Final Environmental Impact Statement

Calpine Fond du Lac Energy Center, LLC

Generation Project

Docket 9343-CE-100

Figure 2-4 Basic processes and equipment for the proposed Calpine natural gas-fired combined-cycle power plant

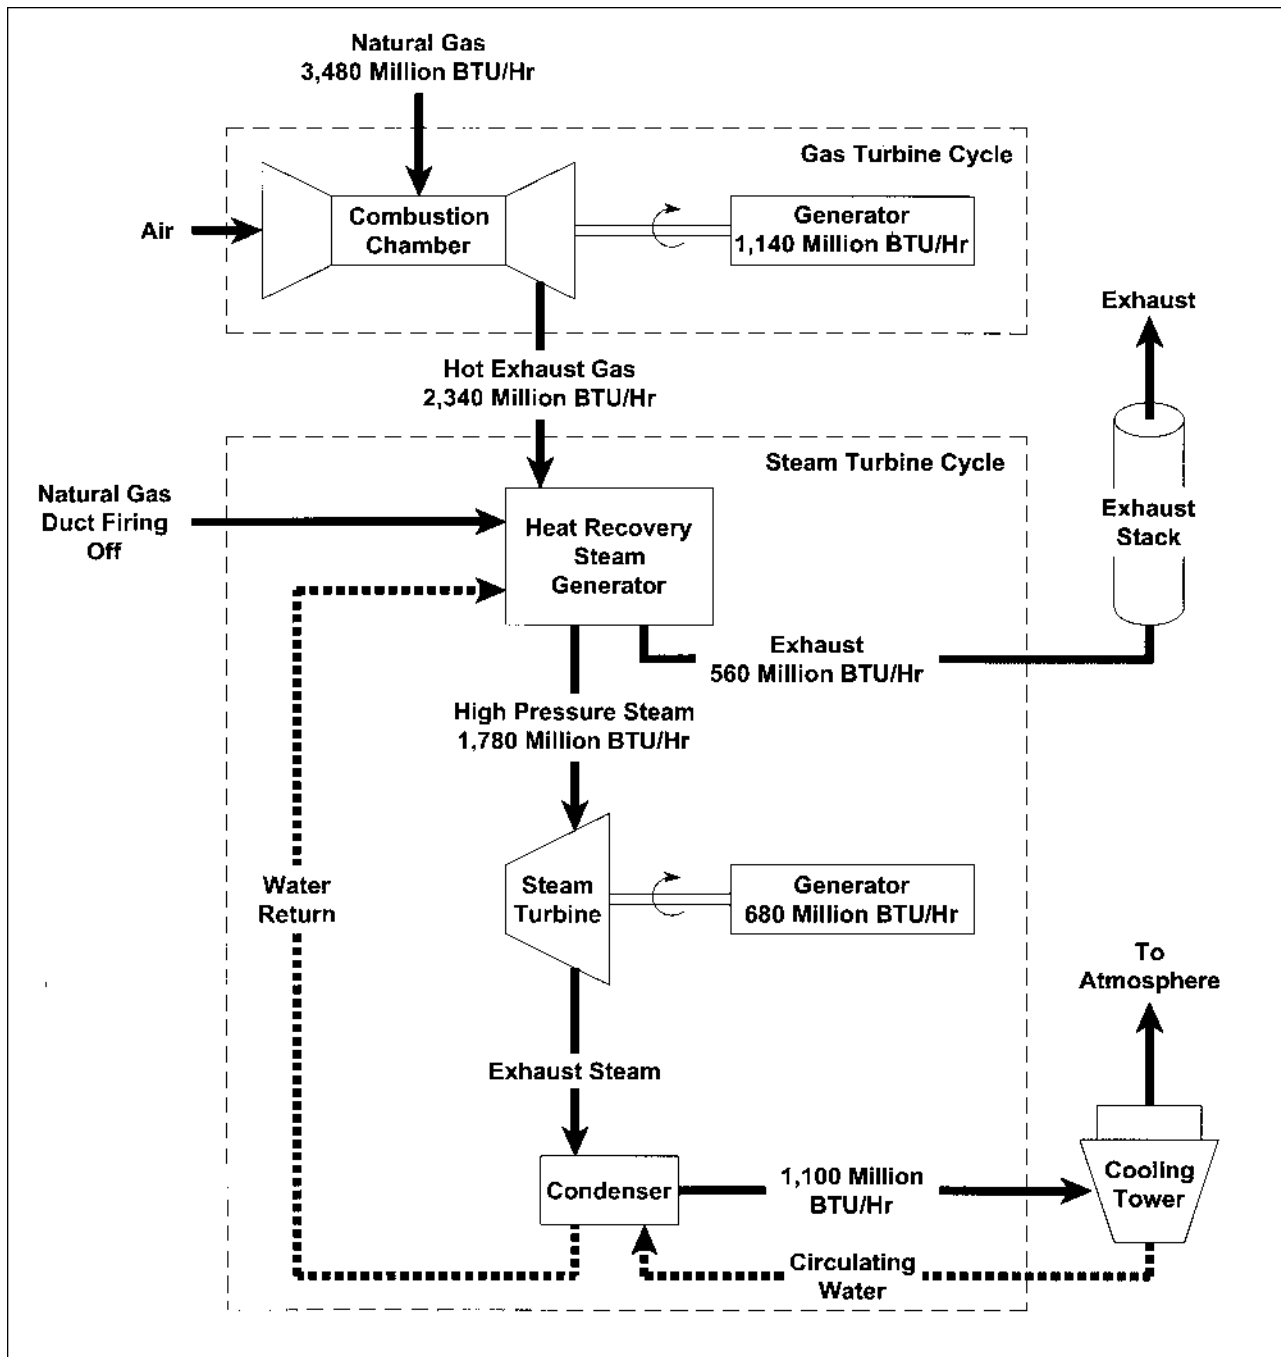
Page 14, Figure 2-4:

Total heat input of the plant should be revised to 3,480 mmBtu/hr to be consistent with Figure 2-4 on Page 14. Also, the total heat input while duct firing should be revised to 4,772 mmBtu/hr.

Figure 2-7 Water mass balance for the proposed Fond du Lac Energy Center in gallons per hour (maximum usage)

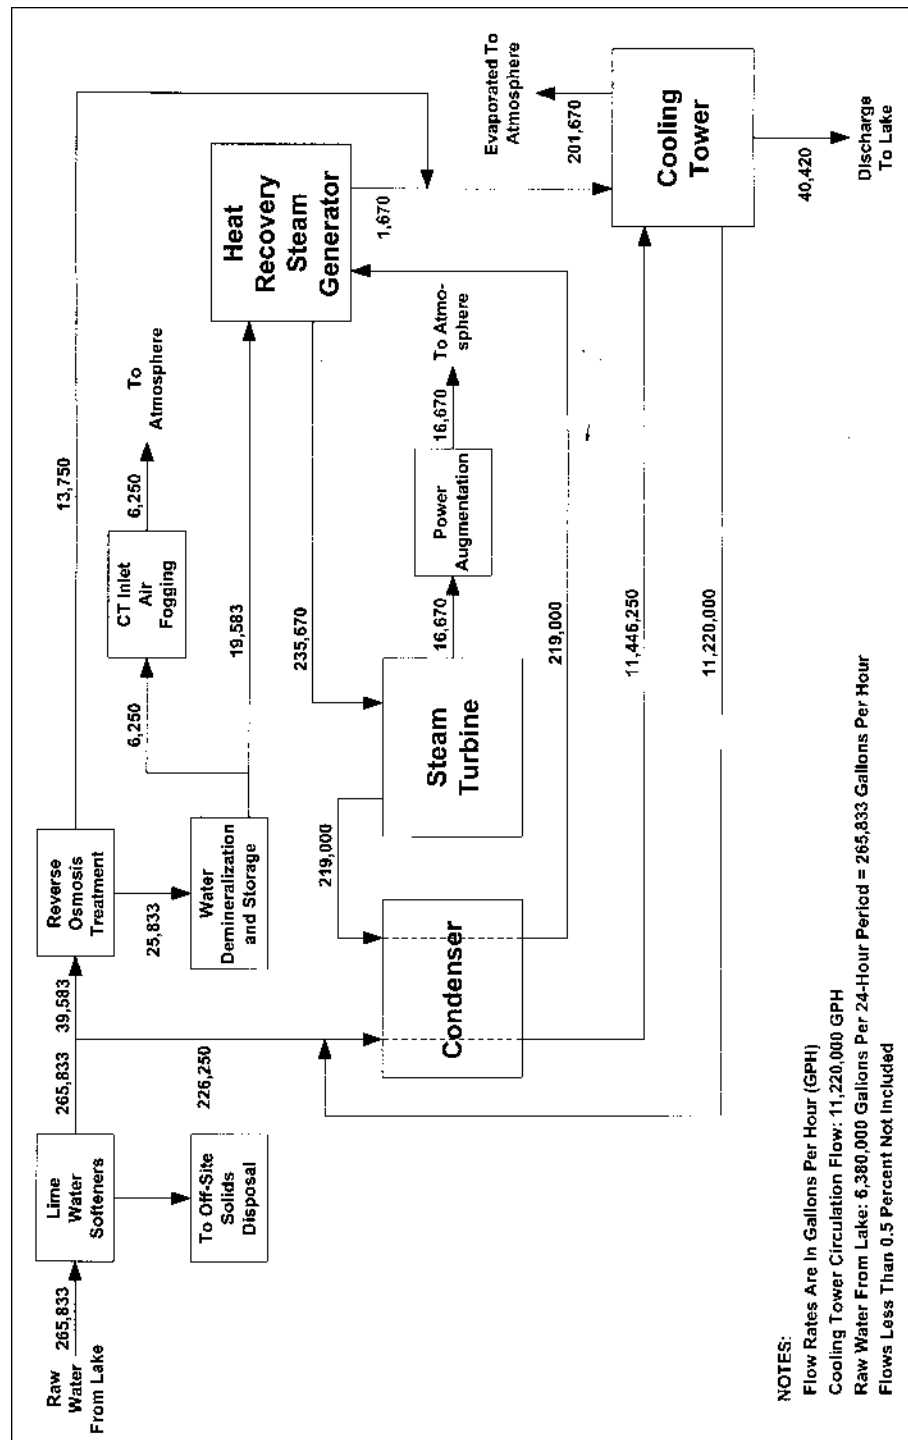
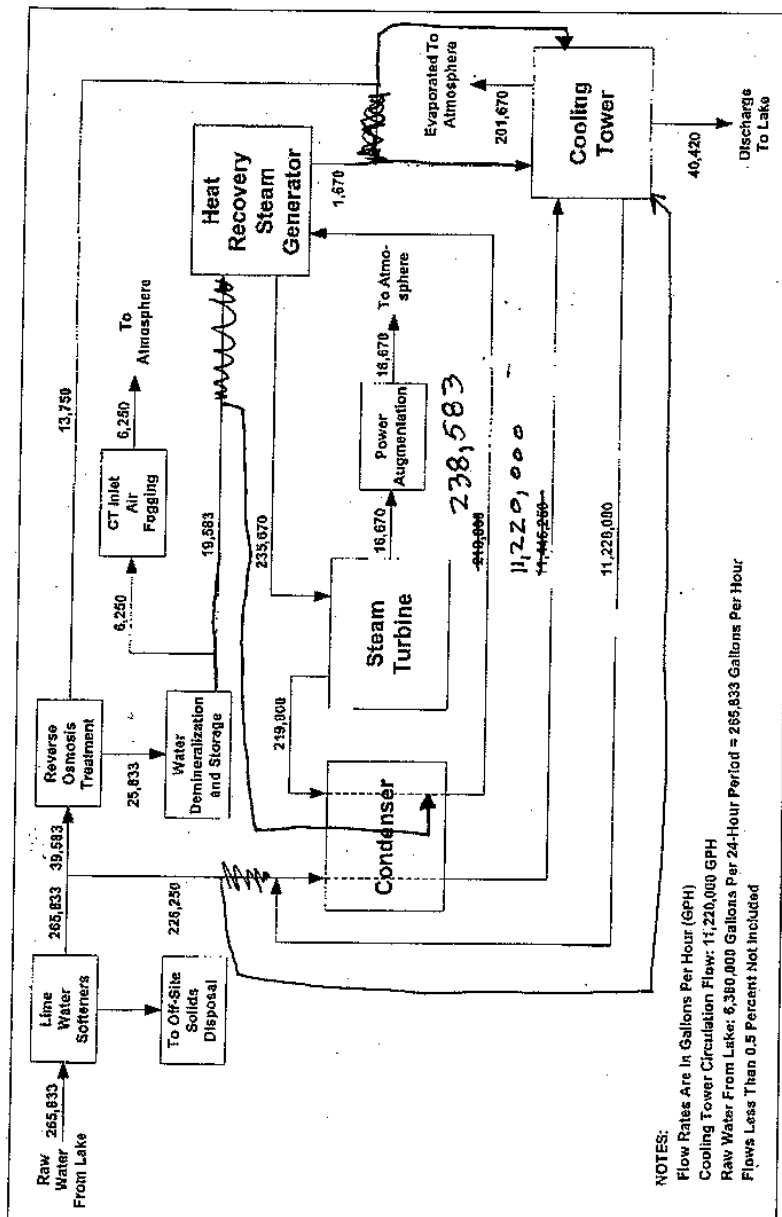
Page 28, Figure 2-7:

Figure 4-4 River Road Site – proposed land cover

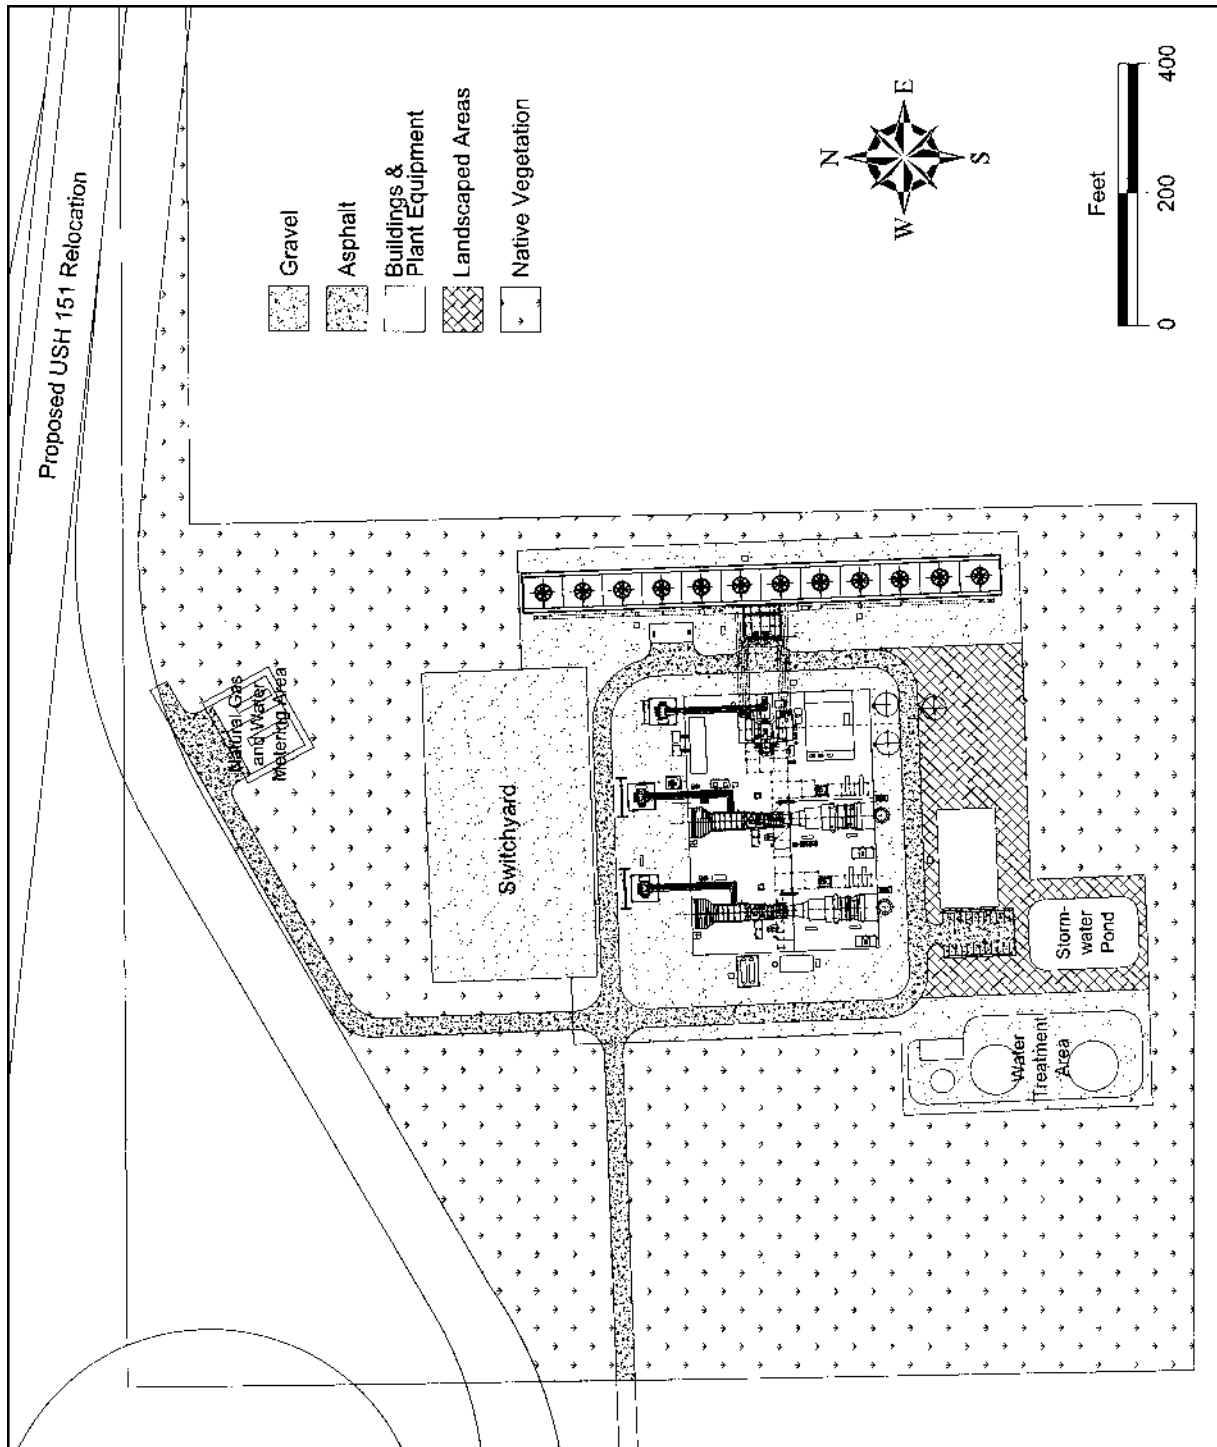
Page 128, Figure 4-4:

Figure 4-4, which describes proposed land cover at the River Road site, includes an outdated version of the plant footprint. Calpine suggests that Figure 4-4 be revised to reflect the latest site layout as provided in Figure 4-5, found on Page 130.
